Location of Construction: 159 Beverly Street		Owner: CPW Development		Phone: 892-3527		Permit No: 010109	
Owner Address: PO Box 4000, Windham, ME 04062		Lessee/Buyer's Name:		Phone:		BusinessName:	
Contractor Name: CPW Development <i>Coley Walsh</i>		Address: PO Box 4000, Windham, ME 04062		Phone: 892-3527		Permit Issued: FEB 14 11	
Past Use: Vacant		Proposed Use: Single Family		COST OF WORK: \$ 73,500.00		PERMIT FEE: \$ 468.00	
Proposed Project Description: New Single Family Home		Signature:		FIRE DEPT. <input type="checkbox"/> Approved <input type="checkbox"/> Denied		INSPECTION: Use Group: R-3 Type: 5B BOC 4 99 Signature: <i>[Signature]</i>	
				PEDESTRIAN ACTIVITIES DISTRICT (P.A.D.) Action: <input type="checkbox"/> Approved <input type="checkbox"/> Approved with Conditions <input type="checkbox"/> Denied		Signature: _____ Date: _____	
Permit Taken By: Gayle		Date Applied For: January 23, 2001 gg		Zone: R-2		Zoning Approval: 333-5016 <i>OK with conditions</i> Special Zone or Reviews: <input type="checkbox"/> Shoreland <input type="checkbox"/> Wetland <input checked="" type="checkbox"/> Flood Zone <i>7 well-zone A ele. 33 - Needs certification</i> <input type="checkbox"/> Subdiv

DETAIL - TYPICAL STEP FOOTING

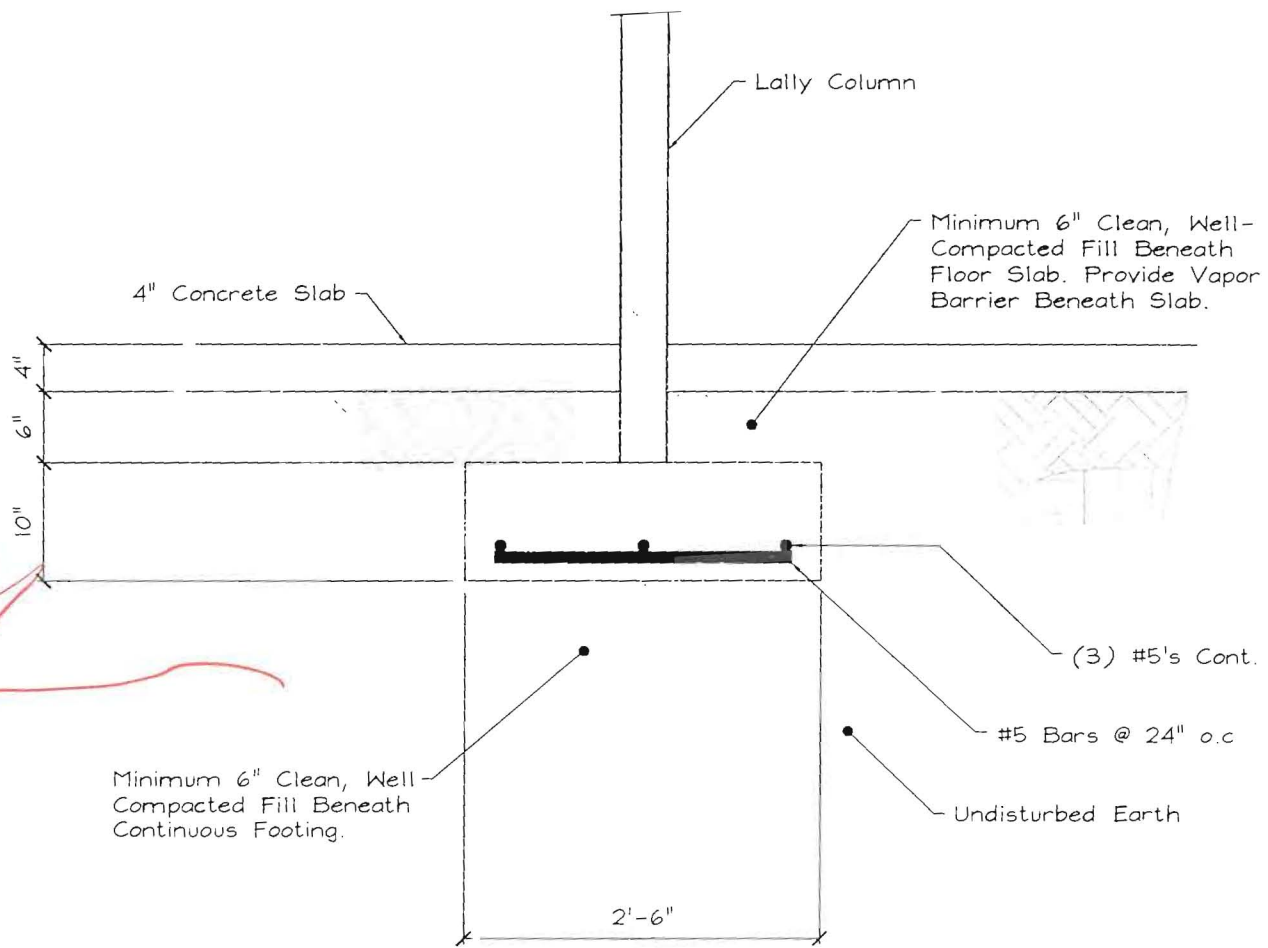
MUST be THIS way

<p>CBW DEVELOPMENT EXPLORATION LOCATION PLAN PROPOSED RESIDENCE LOT 154 BEVERLY STREET PORTLAND, MAINE</p>	
PROJECT NO: 00-0573 DATE: 9/22/00	SCALE: 1" = 20' SHEET: 1

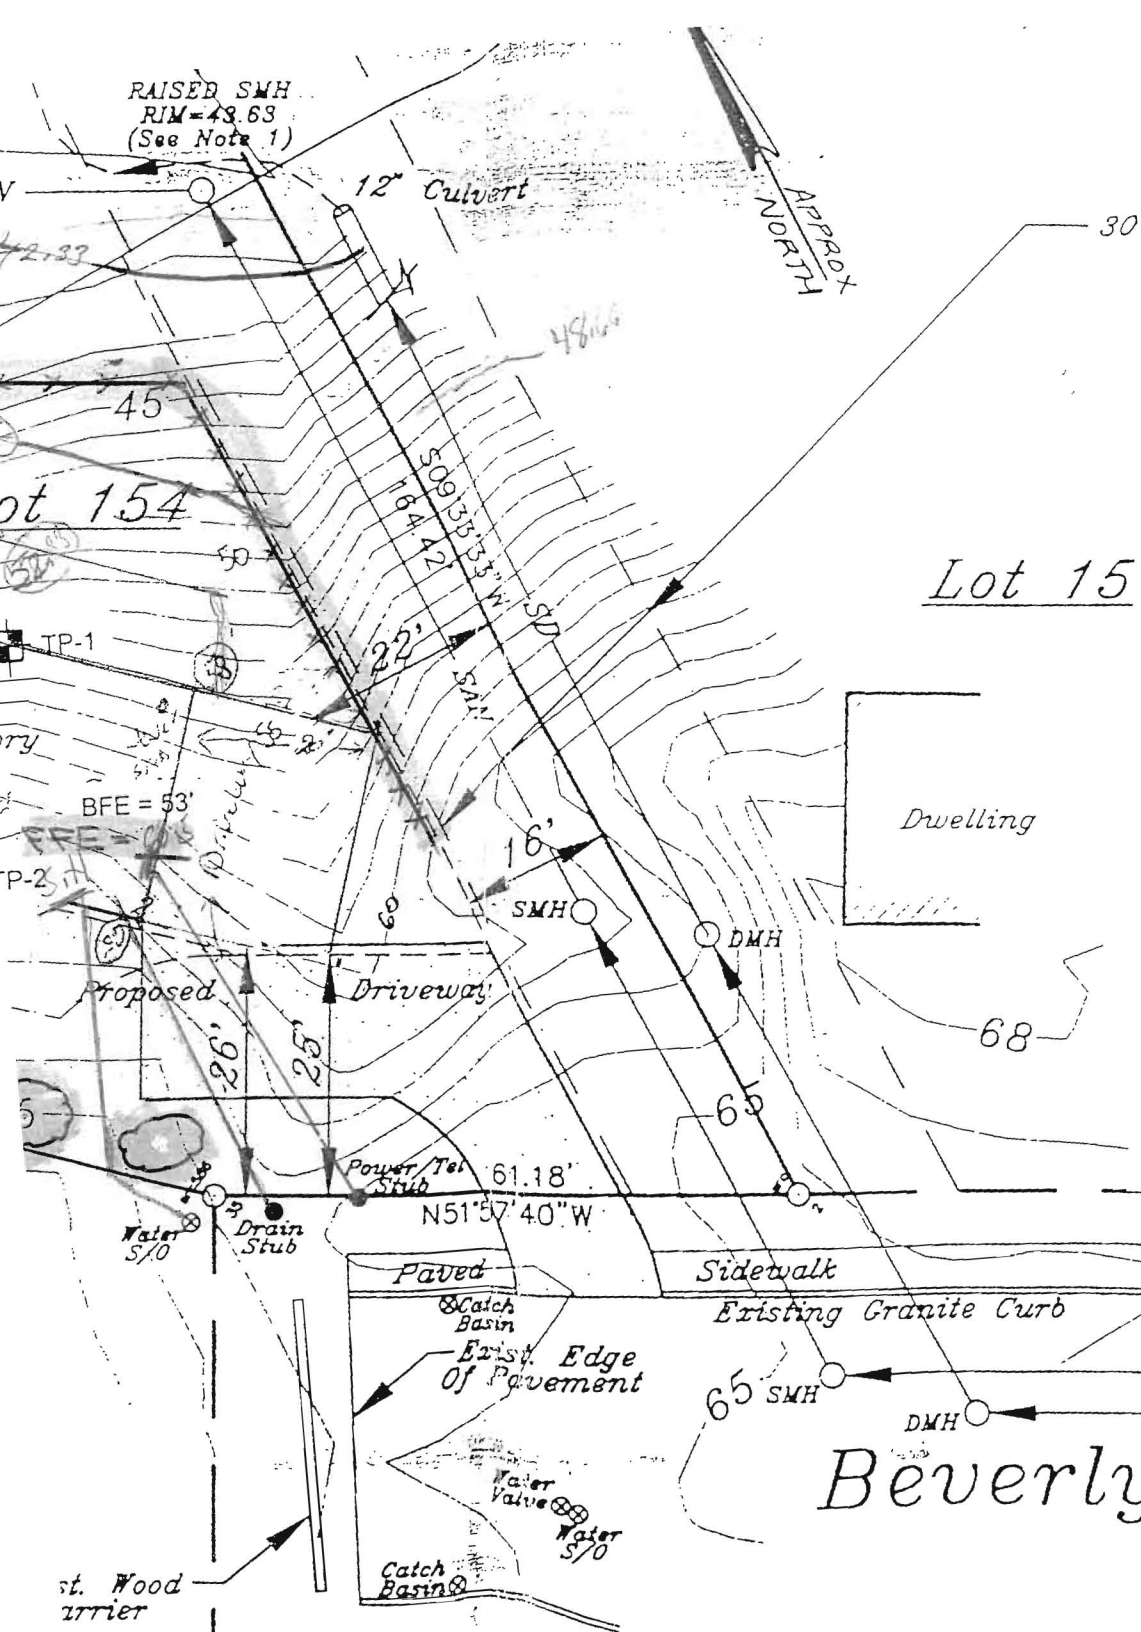
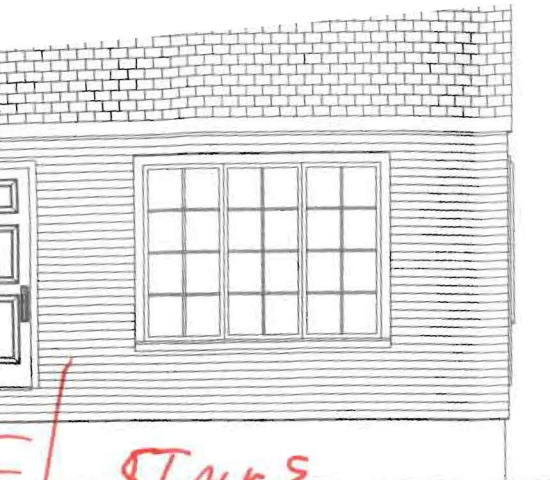
1/21/01 The site plan shows a 24' x 32' bldg with a attached 24' x 24' garage - The structural plans show a 25' x 44' house with no garage - I called Coley Walsh and requested plans that match and are accurate - Tom Blackburn

2/5/01 Tom Blackburn came in with a revised site plan. In discussions with him I found that the building plans were also inaccurate and not what they intended to build, I told him to come back with plans showing exactly what they were going to build. Bldg & Plat plan must match

Tim & Jay discussed Geo Survey - Tim will write letter to us confirming that his original report dated 25 Sept 00 remains valid even w/ changes in position & location of Bldg. - Builder w/ Submit A mended Site plan for approval

2/28/01 - Mended plat plan submitted & approved by Jay/George/Mike N. R. Spoke w/ Coley Walsh, requested verification of NEC & BOCA 99 compliance from SMTC - Also, he will have surveyor verify foundation setbacks - Discussed BOCA 99 TREAD/RISE/HAND CLEARANCE FOR STAIRS

Right Elevation

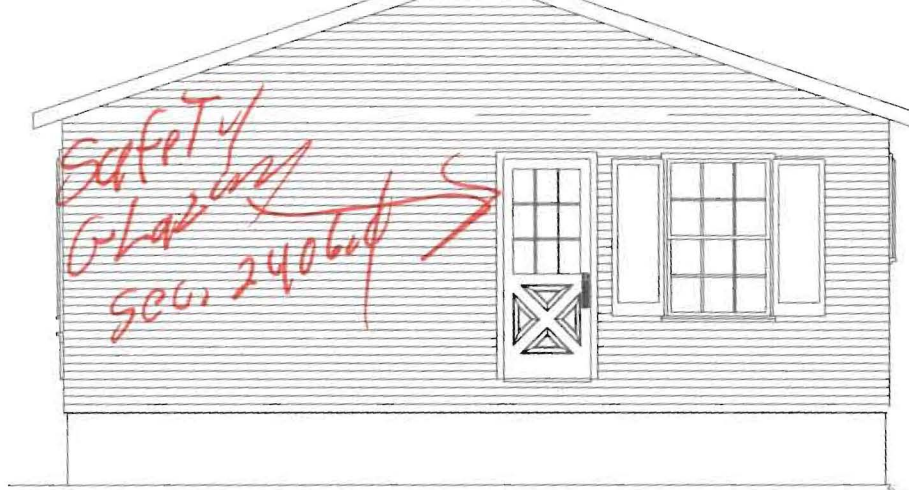
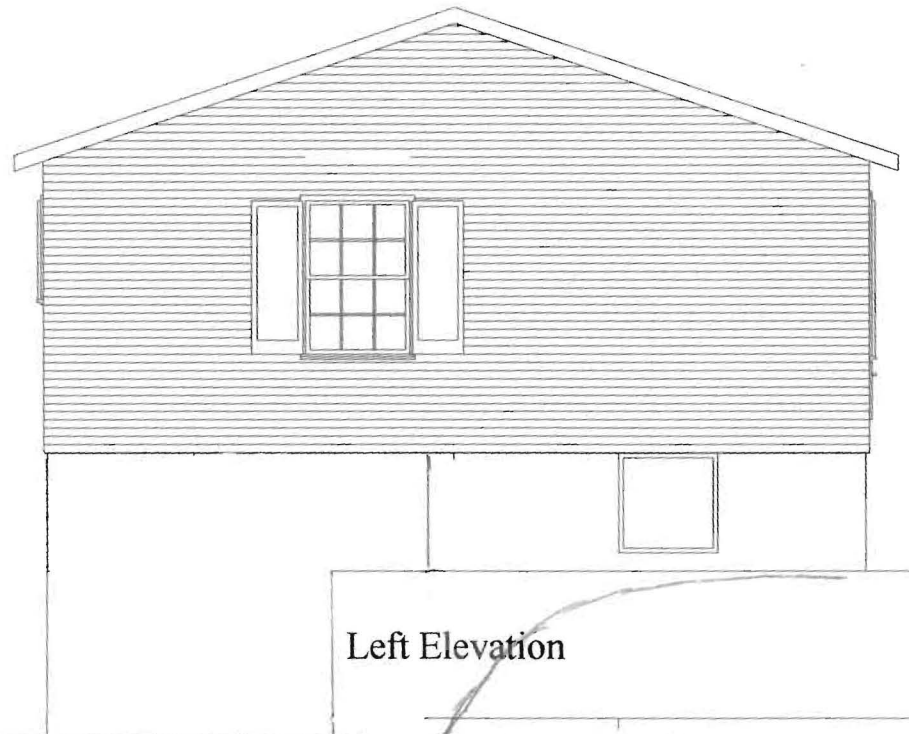
STAIRS
 sec. 1014.0
 Guardrails sec. 1022.0
 Handrails sec. 1021.0

FOUNDATION PLAN
SCALE: 3/16" = 1'-0"

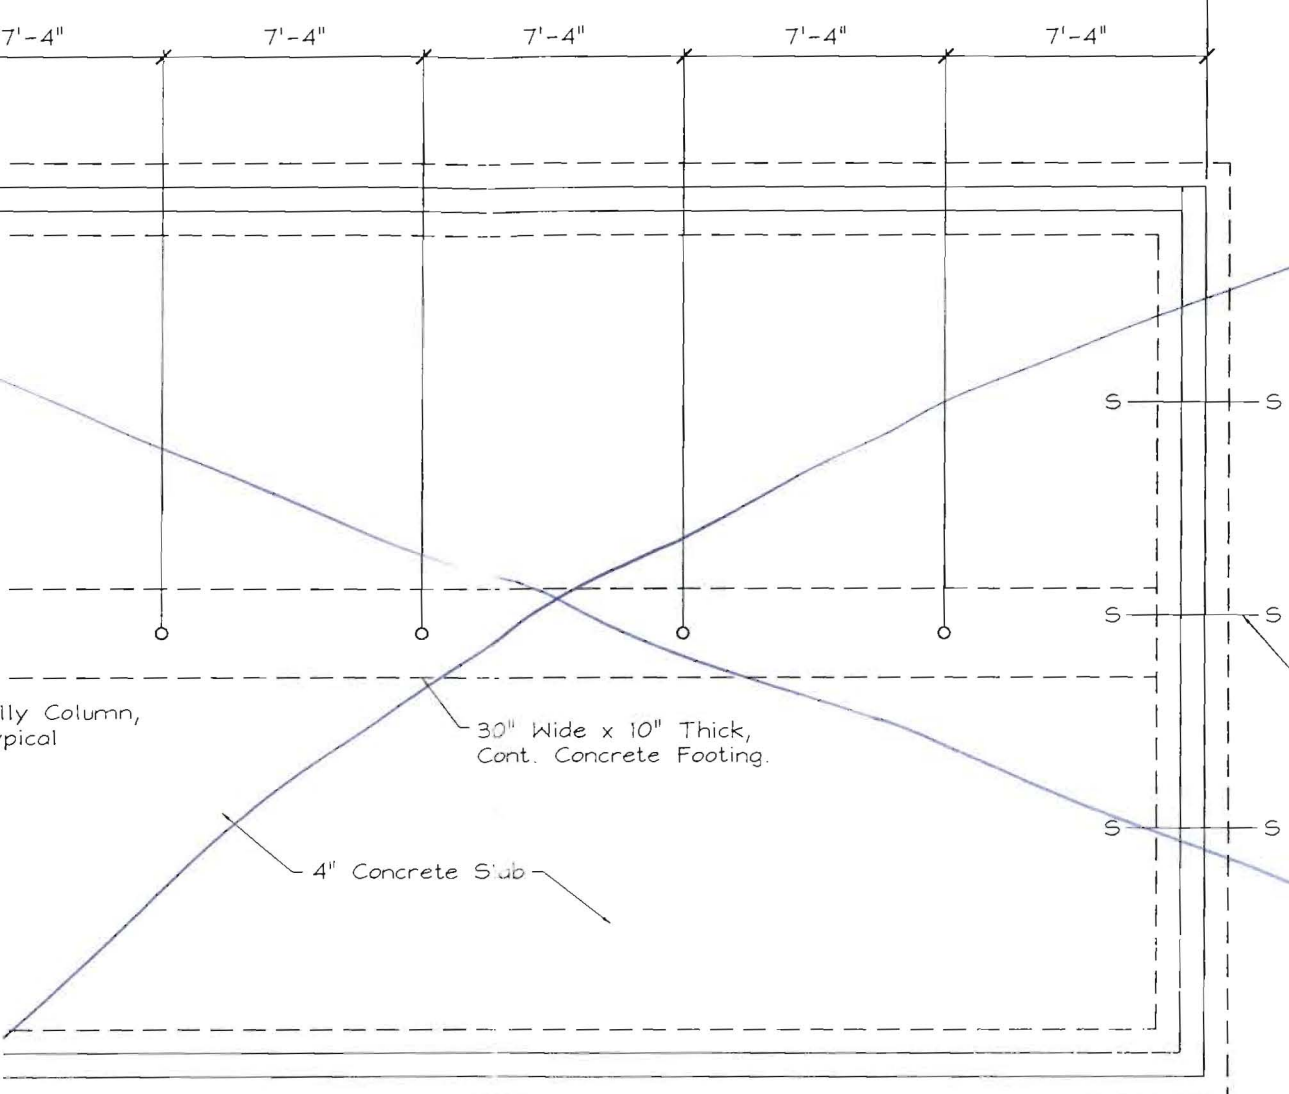
✓ ③ No current (updated foundation plan shown), update Rear Elevation location of Door.

*OLD
PLANS
see fenced
dated
2/5/01*

*Very Important
Importance of depth
shall be done
as per plan.*

Right Elevation

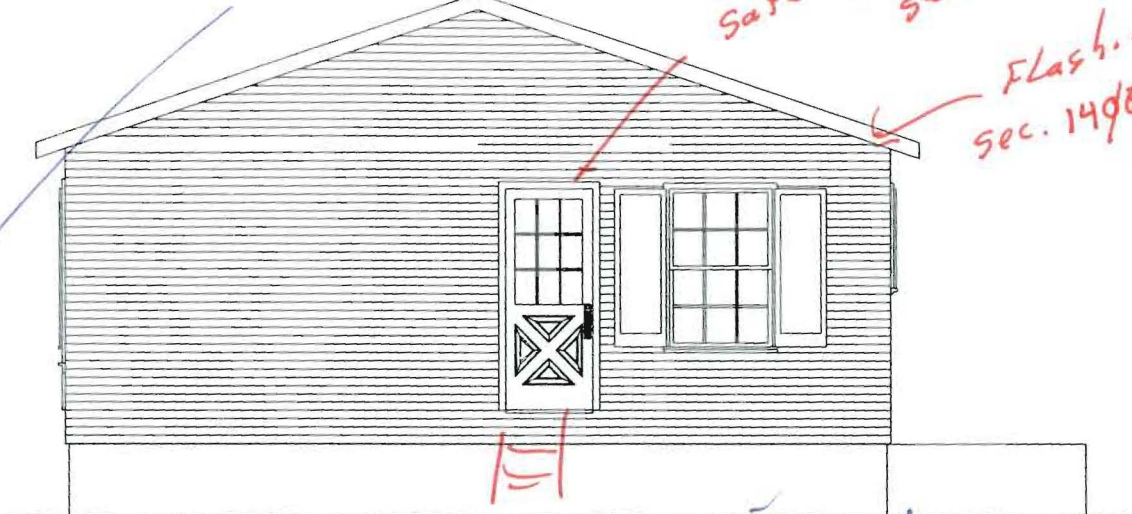
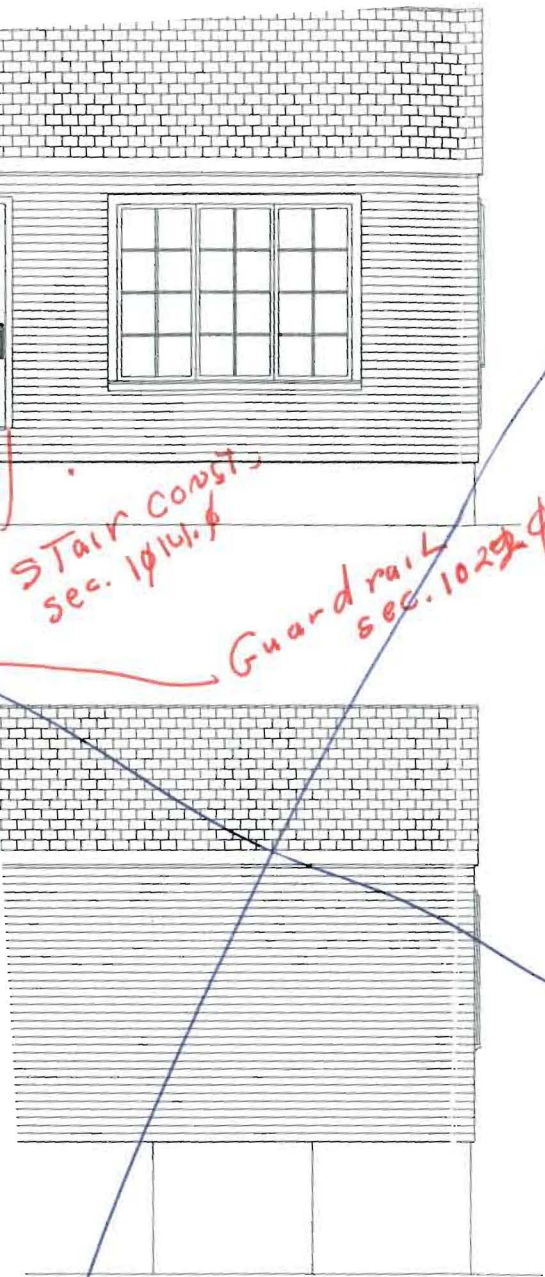
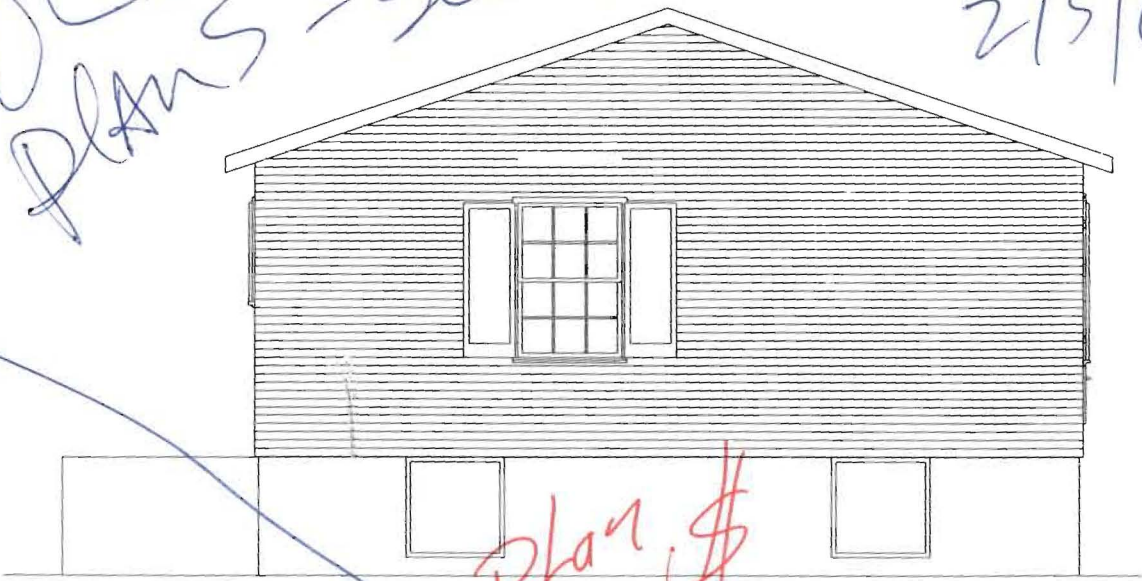
OLD PLANS - see revised Dated 2/5/01

See Foundation Plan \$
Important!
